REPORT NO: DS 2023-003

SUBJECT: Modifications to Draft Plan of Subdivision 30T-19601, Badenview
Developments Inc., Wilmot Employment Lands, New Hamburg

Attachment A	Approved Draft Plan
Attachment B	Changes to Township Conditions of Draft Approval
Attachment C	Revised Draft Plan
Attachment D	West property line conceptual cross-sections

Part of Lot 20, North of Bleams Road
Part of Lot 20, South of Snyders Road
Township of Wilmot
Regional Municipality of Waterloo

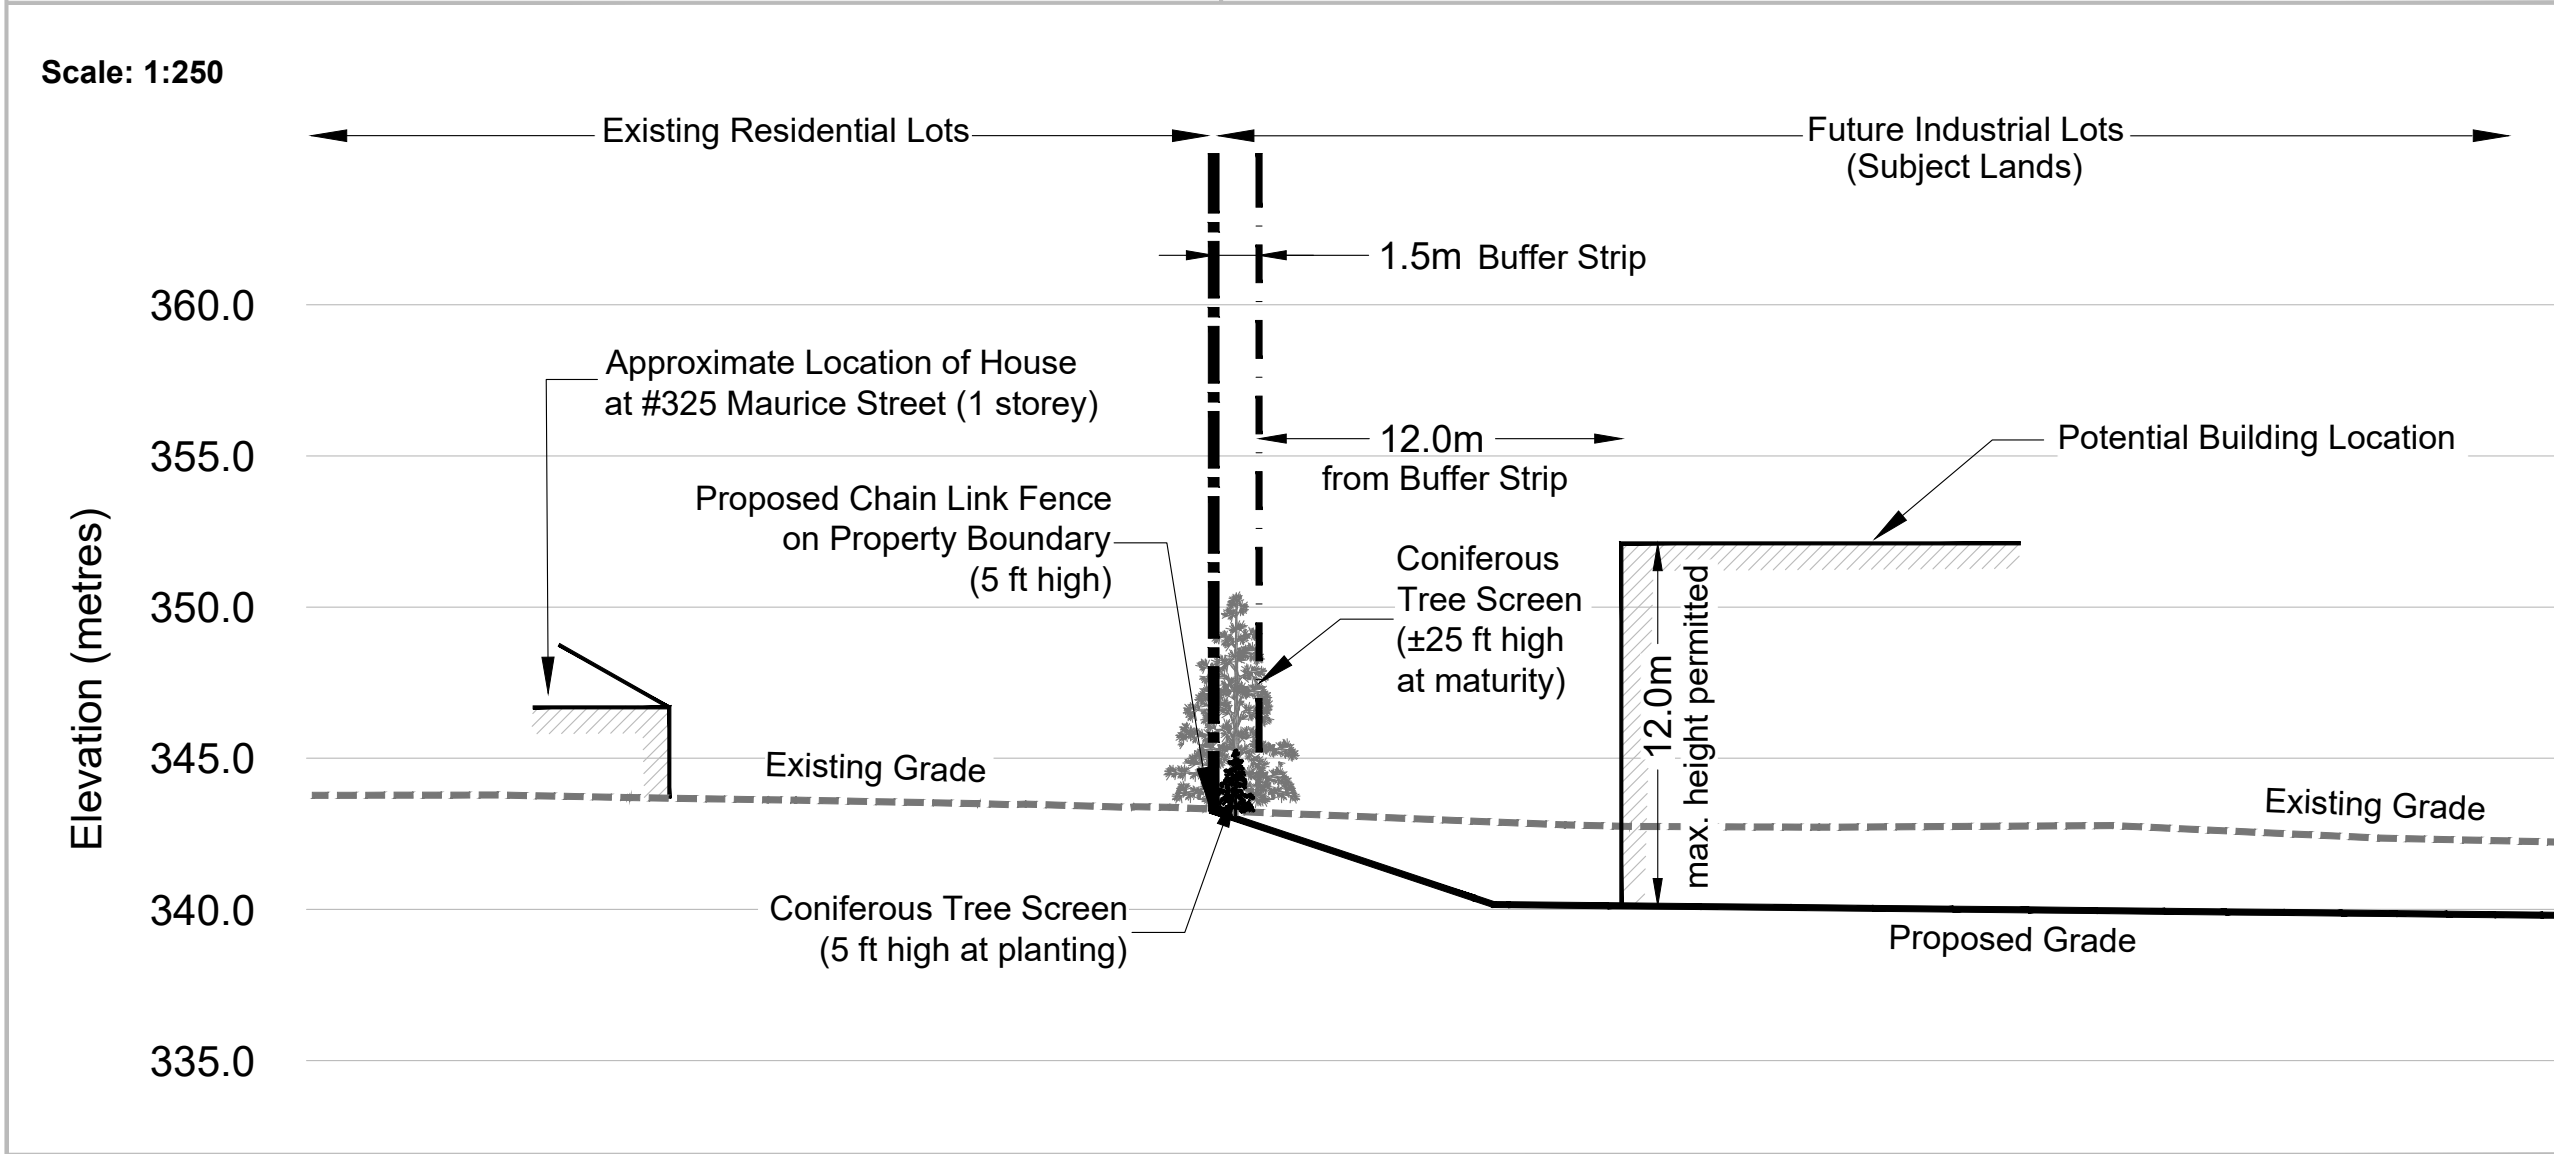
While not required for noise mitigation, the berm was anticipated to provide the added benefit of visual buffering. To ensure that visual mitigation measures remain in place along the west property line, the developer proposes to maintain a 13.5m buffer area between the west property line and any proposed building. This area will accommodate a 3:1 slope from the higher elevation of the residential lands to the lower finished elevation of the employment lands. Conceptual cross-sections at several points along the west property line illustrate the grade difference and proposed landscaping at or close to the rear property line. These illustrations are included as Attachment D.

Staff propose that the Township retain an easement over the proposed buffer area to ensure the slope and landscaping are preserved. The revised conditions of draft approval implement the requirements for the 13.5m landscaped buffer secured through a Township easement.

3. **That a 13.5m easement be conveyed to the Township of Wilmot along the west side of Block 1 for the purposes of preserving a landscaped 13.5m buffer along west property line that abuts residential development.**
